From: [S Mason](#)
To: [Rebecca Noecker](#)
Cc: [Spencer Miller-Johnson](#); [*CI-StPaul Contact-Council](#)
Subject: Public Comment in Opposition to Proposed EGAOD changes. Add a rear setback and step back to the EGAOD.
Date: Friday, July 19, 2024 1:06:09 PM
Attachments: [1- ANNOTATED Parritz public comment presentation.pdf](#)
[2-ANNOTATED Parritz public comment presentation.pdf](#)
[3-ANNOTATED Parritz public comment presentation.pdf](#)
[4-comments.pdf](#)
[5-Comments.pdf](#)

ANNOTATIONS TO PUBLIC COMMENT IMAGES

695 Grand Ave: Massing as constructed

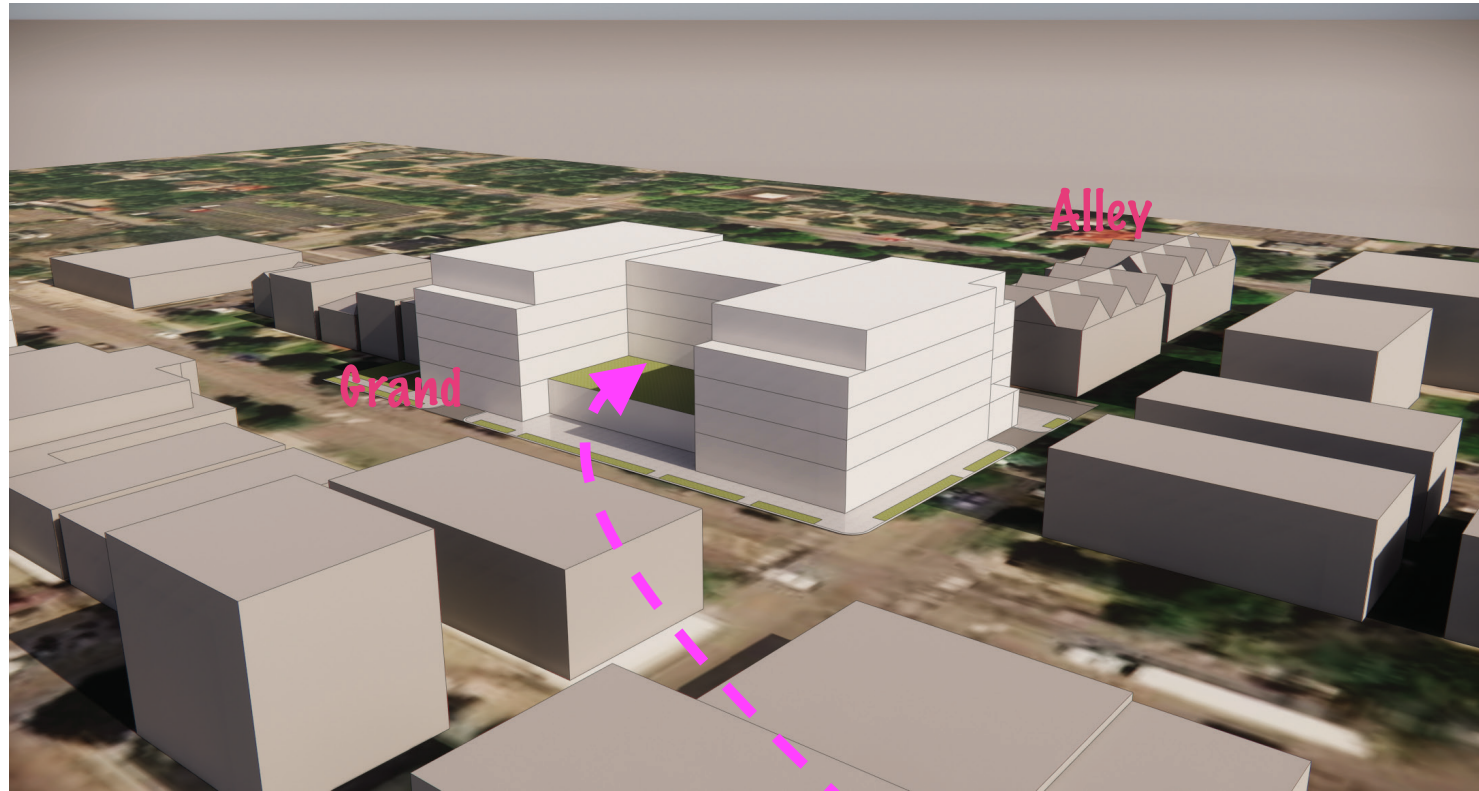
1 Why, in all of these, is there LESS bulk and building mass facing Grand?

And MORE bulk close the neighbors?

Why is there a giant area on Grand that could be built, but wasn't?

695 Grand Ave: Massing as restricted by proposed amendments

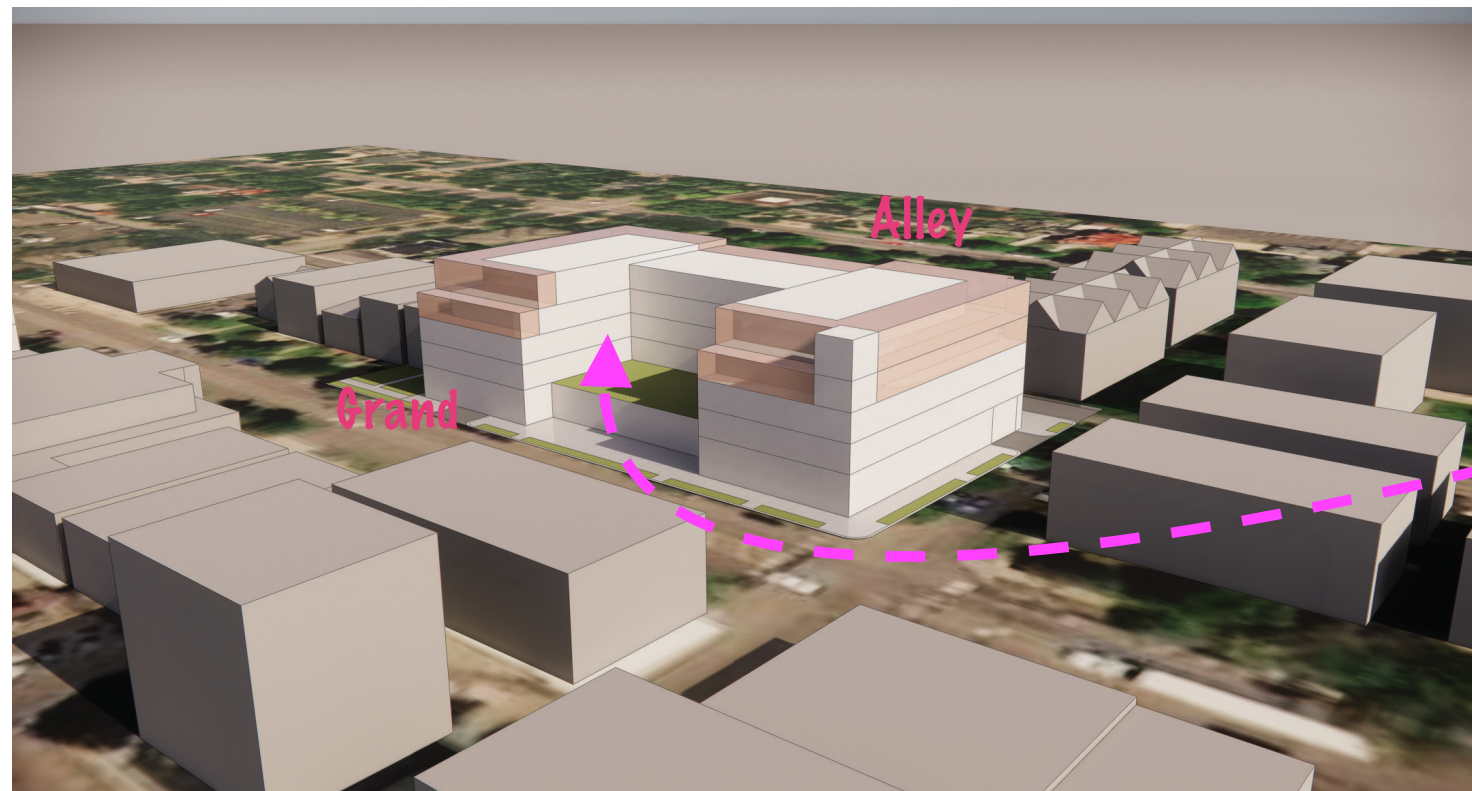
Why is it NOT built?

695 Grand Ave: Possible Massing

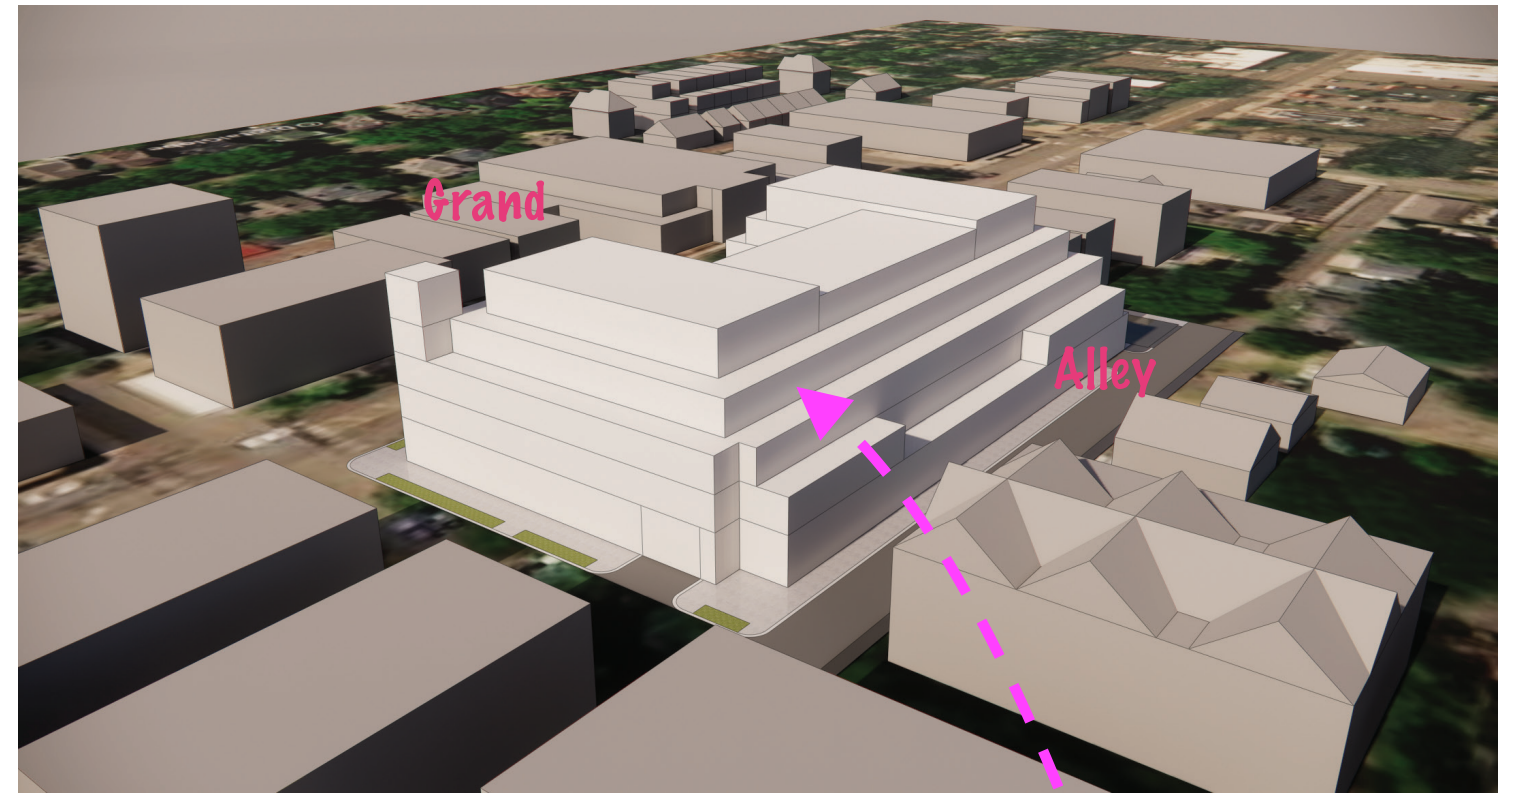
Imagine this flipped. Why is there more height and more massing at the rear, toward the residential neighborhood?

Residential neighbors near 695 Grand have been negatively impacted by the tall walls that were constructed:

- * ice build up in the 6-month fully shadowed alley has impeded access & trash collection
- * a 90 dBA piece of equipment installed in the narrow strip of land along the alley runs 24-7 in the summer, limiting neighbors ability to use outdoor spaces and have open windows.
- * Litter (chiefly cigarette butts & dog poop) is a huge problem as the building has no outdoor space for employee smoking or dog relief.

This would be somewhat better.

Removing the highlighted areas would be an improvement for residential neighbors to the north. However, there is still too much building oriented toward low density.

Why is the building oriented away from Grand?

Since Grand needs development, then the building and its bulk, as well as its noise, deliveries and activity should all be oriented toward Grand

These "POSSIBLE MASSINGS" are better than what was built at 695 Grand. The lower images show better "transitions" to sensitive areas, to the housing & neighbors NOT on Grand

734 Grand Ave: Possible Massing

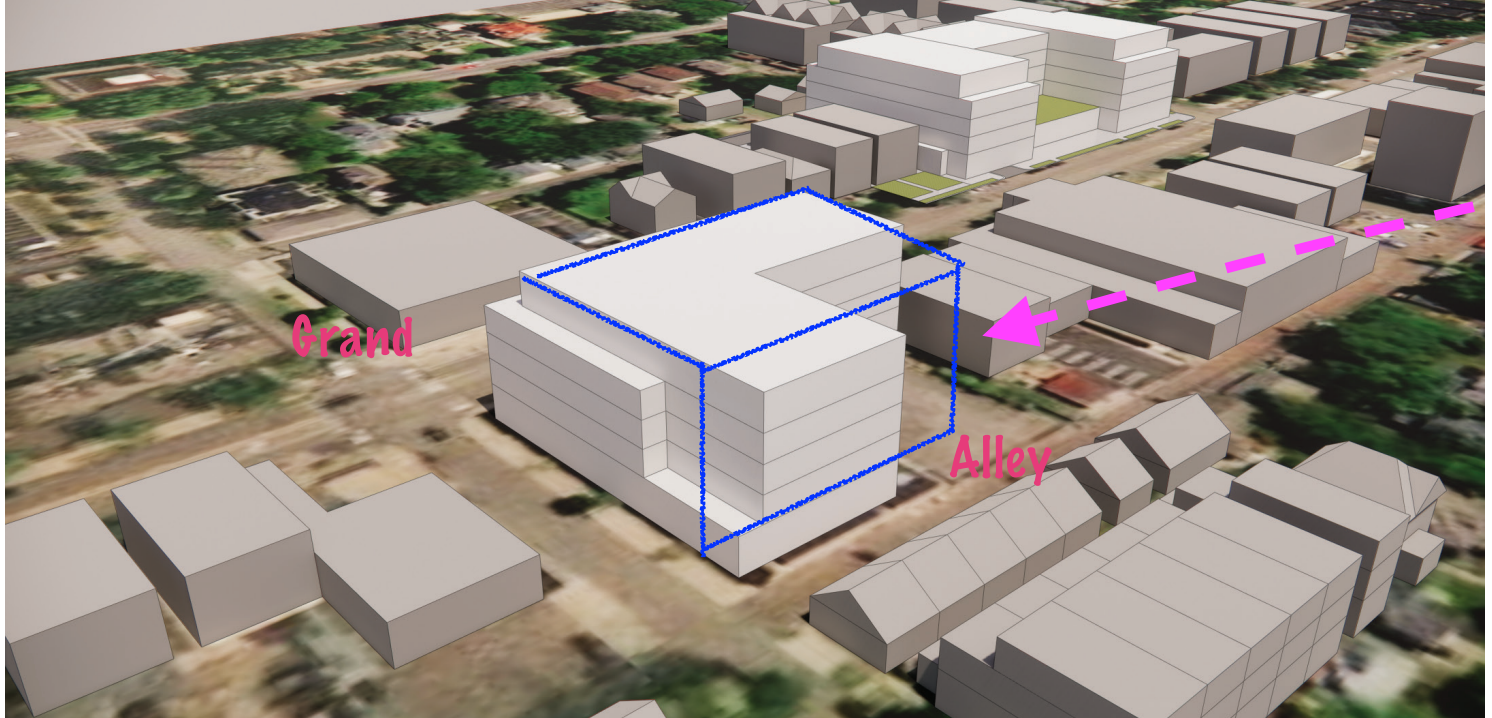
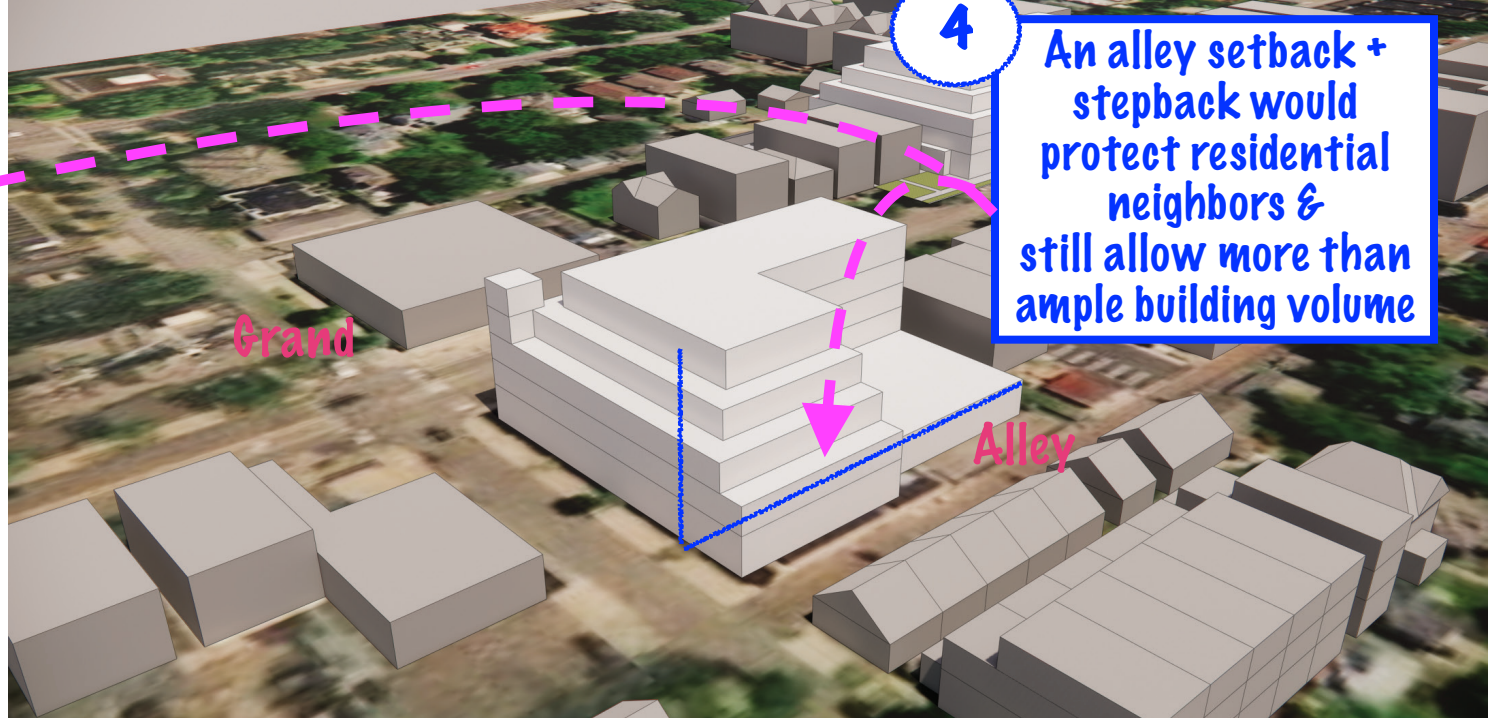
But why does the Tall Height and Large Bulk need to come all the way back to the alley? Why not provide a buffer space to protect the residents on Lincoln from the noise, loss of privacy, etc.

This is the Walgreens sight. They currently have a tall fence to protect the neighbors from noise etc. Parking comes from Grand. Deliveries happen from Grand & Grotto. The alley is a quiet buffer, This design puts all the noise, traffic and delivery pressure on the residential alley. There is no place for moving trucks and deliveries for the (presumed) 80+ luxury apartments. This layout would likely have noisy equipment installed right at the alley, close to neighbors. This design reduces privacy & provides no buffer.

The Overlay must provide protections for the neighbors on Lincoln, Summit, & side streets.

An alley setback + stepback would protect residential neighbors & still allow more than ample building volume

Here is an image of 695 Grand as built, with December Shadows.

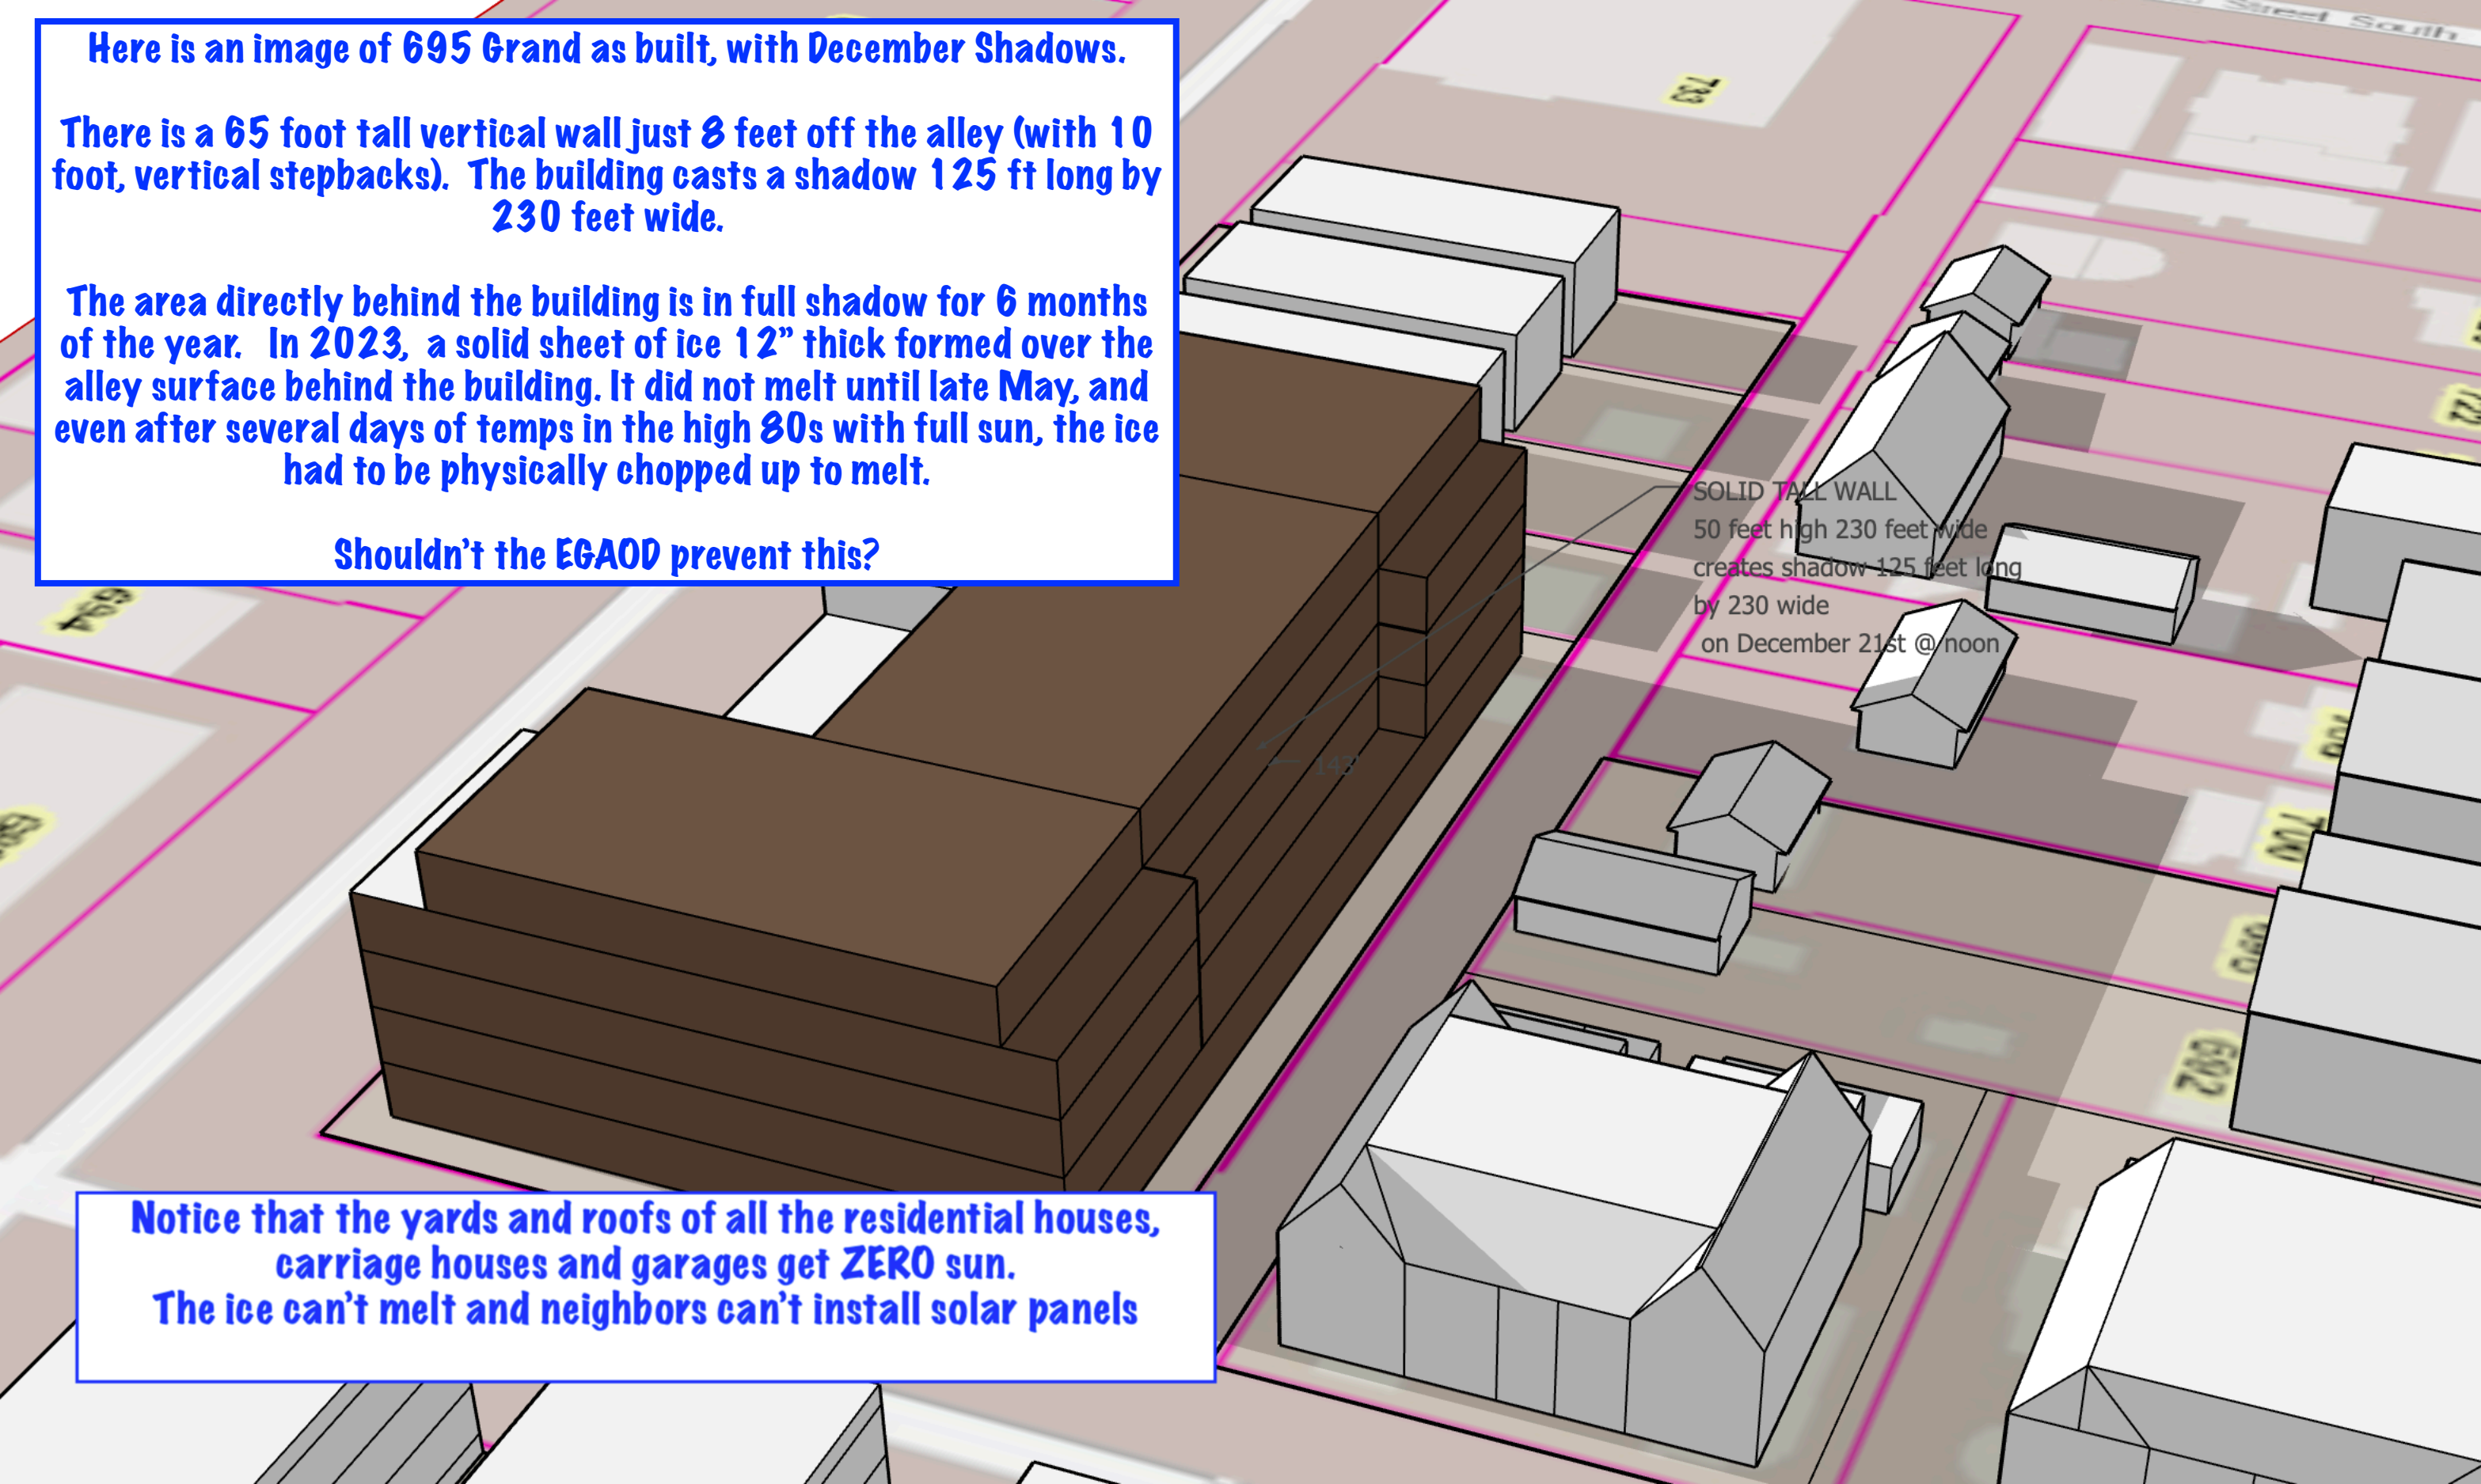
There is a 65 foot tall vertical wall just 8 feet off the alley (with 10 foot, vertical stepbacks). The building casts a shadow 125 ft long by 230 feet wide.

The area directly behind the building is in full shadow for 6 months of the year. In 2023, a solid sheet of ice 12" thick formed over the alley surface behind the building. It did not melt until late May, and even after several days of temps in the high 80s with full sun, the ice had to be physically chopped up to melt.

Shouldn't the EGAOD prevent this?

SOLID TALL WALL
50 feet high 230 feet wide
creates shadow 125 feet long
by 230 wide
on December 21st @ noon

Notice that the yards and roofs of all the residential houses, carriage houses and garages get ZERO sun.
The ice can't melt and neighbors can't install solar panels

Here is an image of 695 Grand flipped, with December Shadows.

This simple move puts the height and massing toward Grand, mitigating negative affects on the residential neighborhood.

Why doesn't the EGAOD require this?

Notice that the yards and roofs of all the residential houses, carriage houses and garages get ice-melting sun.
They can install solar panels
